BGS #3478

Bradbury Mountain State Park Campground

10.21.2024

Addendum #1

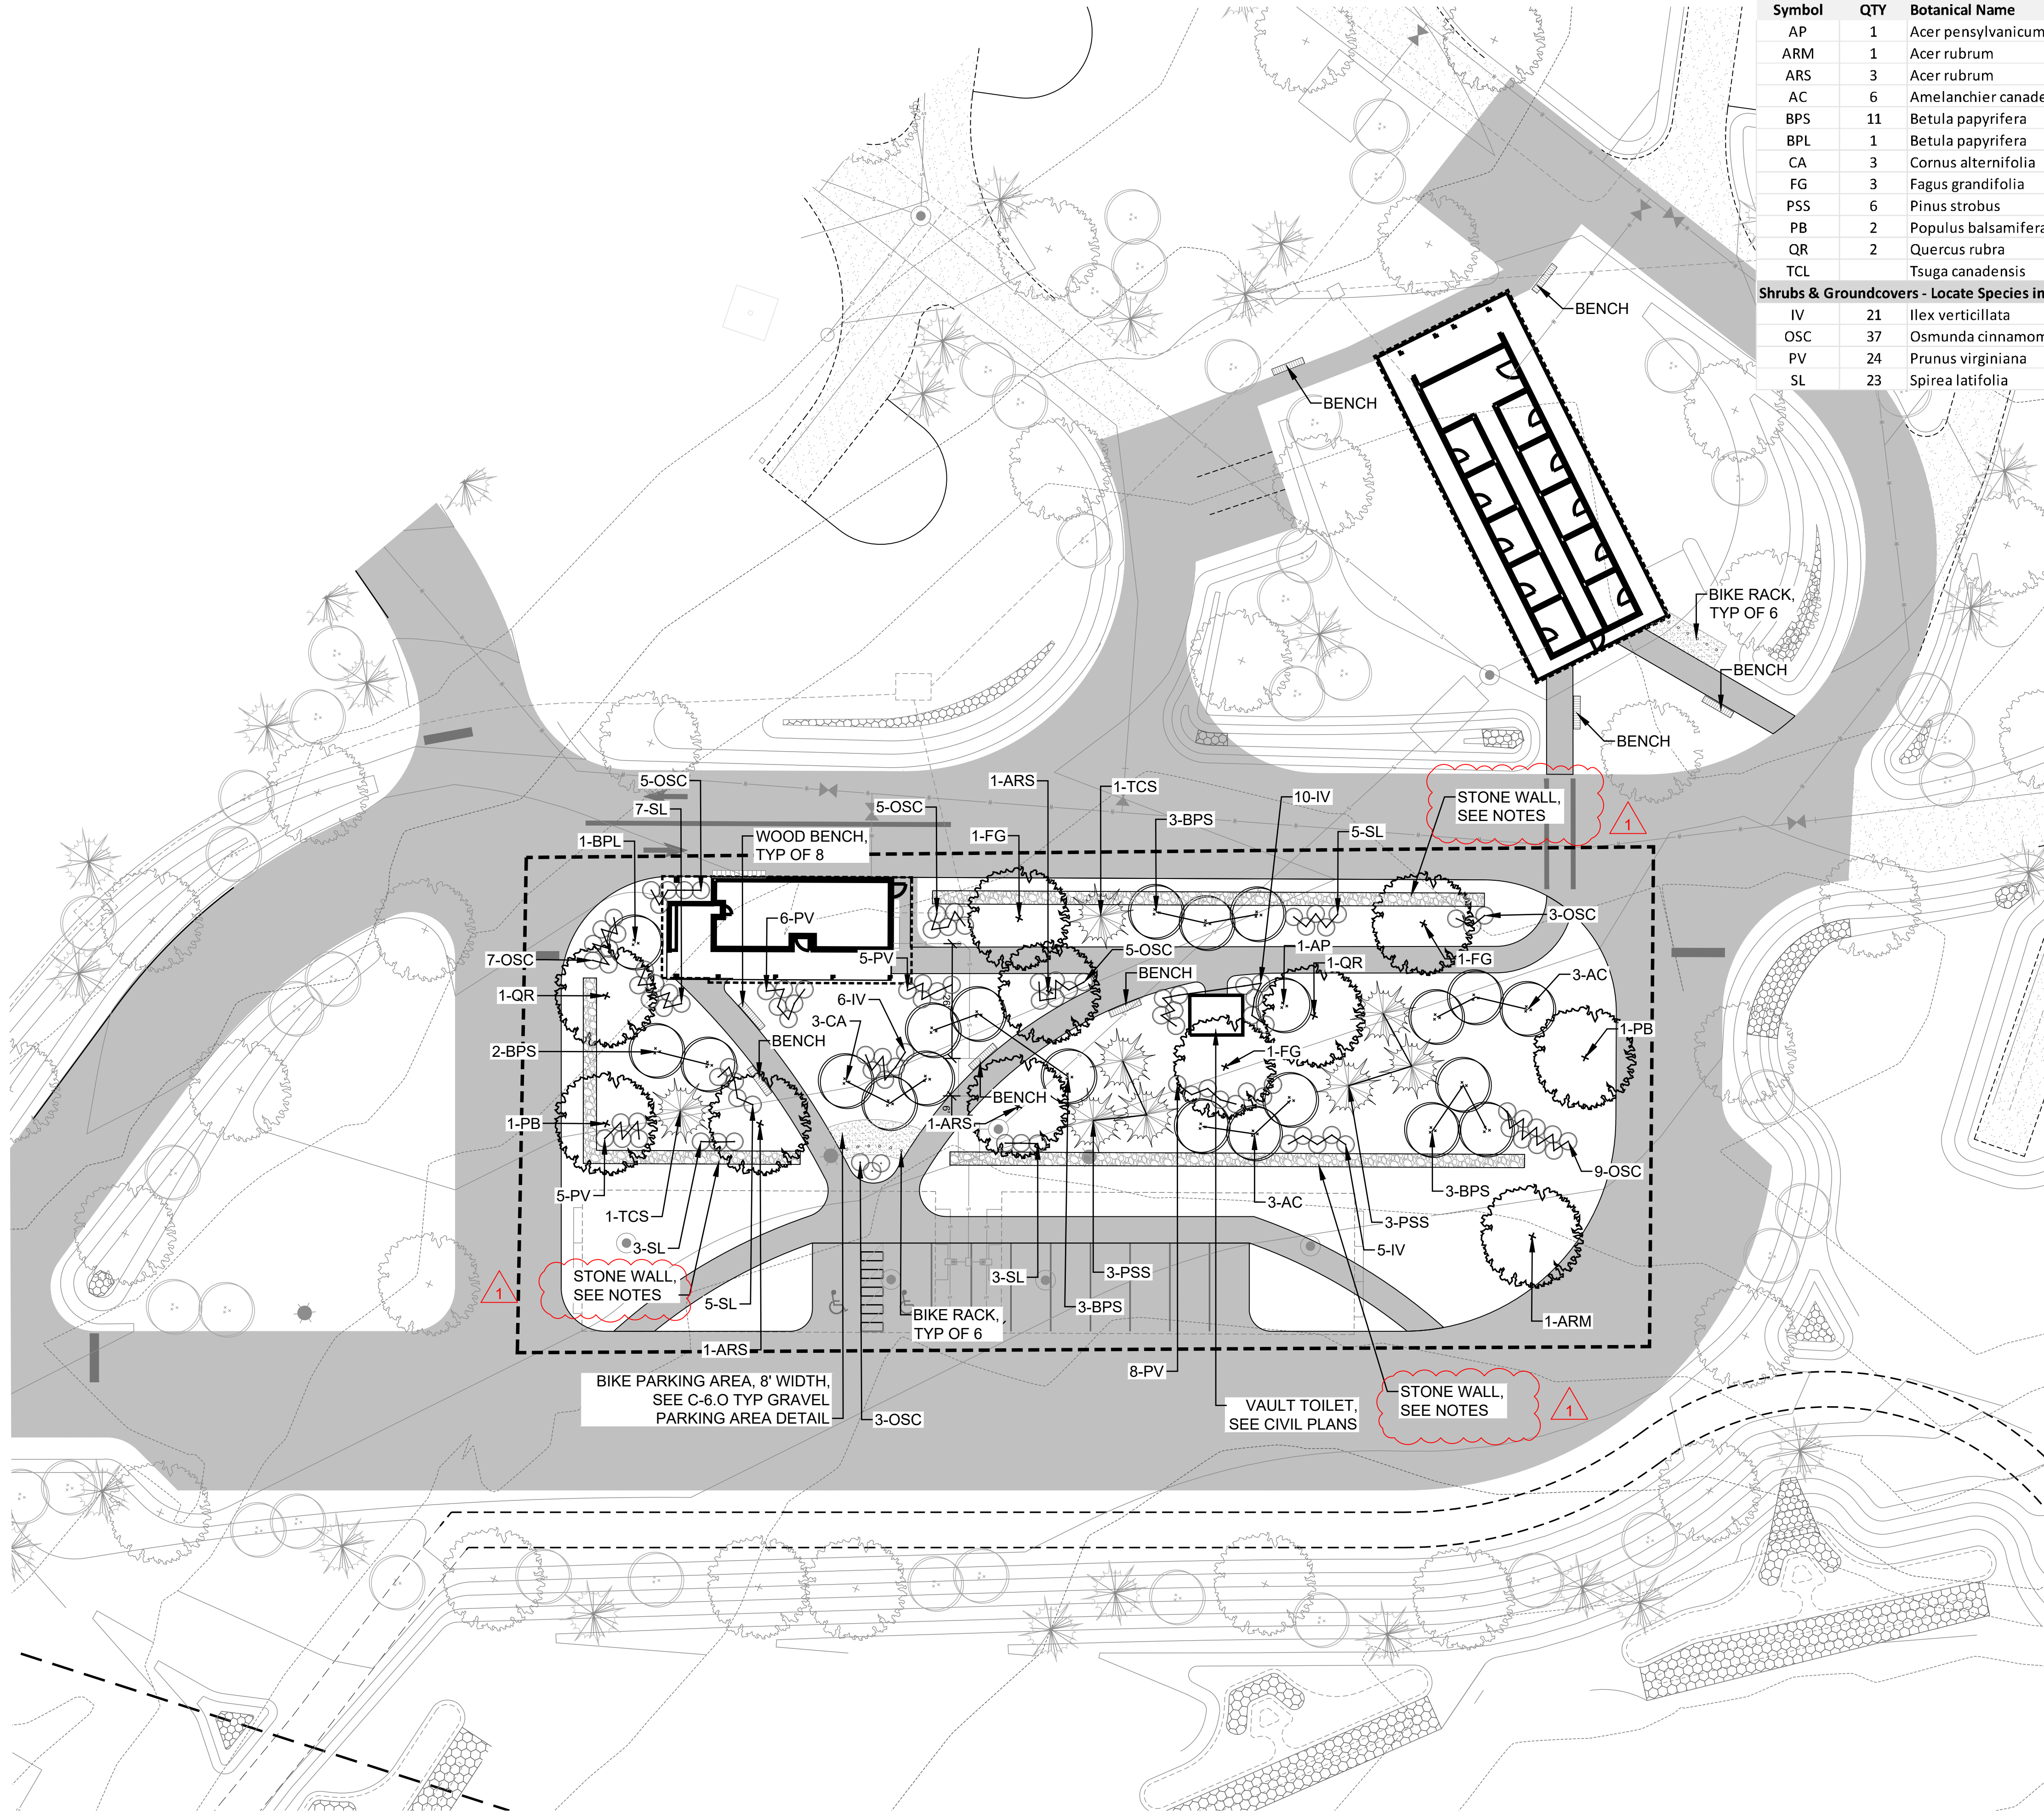
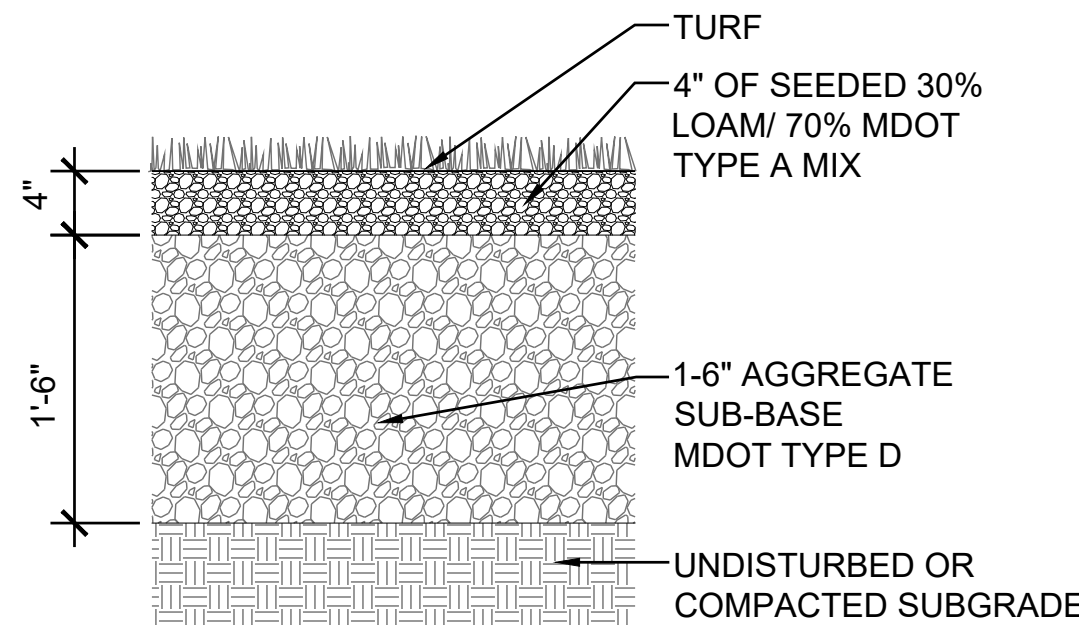
- ADDENDUM #1 NOTES:
- EDUCATIONAL AND DIRECTIONAL SIGNAGE HAS BEEN REMOVED AS THEY ARE TO BE DONE BY THE PARK SERVICE.

2 Boulder Setting
Scale: 1/2"=1'-0"

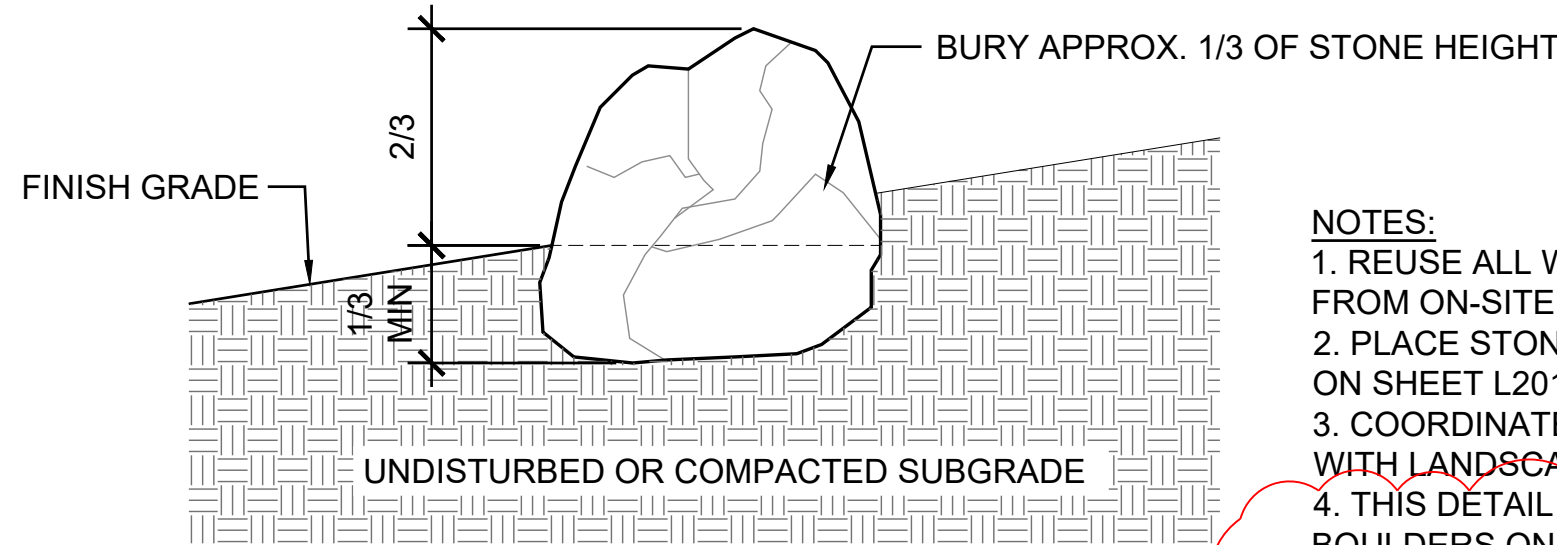
- NOTES:
1. REUSE ALL WEATHERED BOULDERS FROM ON-SITE STOCKPILE.
2. PLACE STONES PER ENLARGEMENTS ON SHEET L201.
3. COORDINATE PLACEMENT OF STONES WITH LANDSCAPE ARCHITECT.
4. THIS DETAIL APPLIES TO INDIVIDUAL BOULDERS ONLY AND NOT THE STONE WALLS.
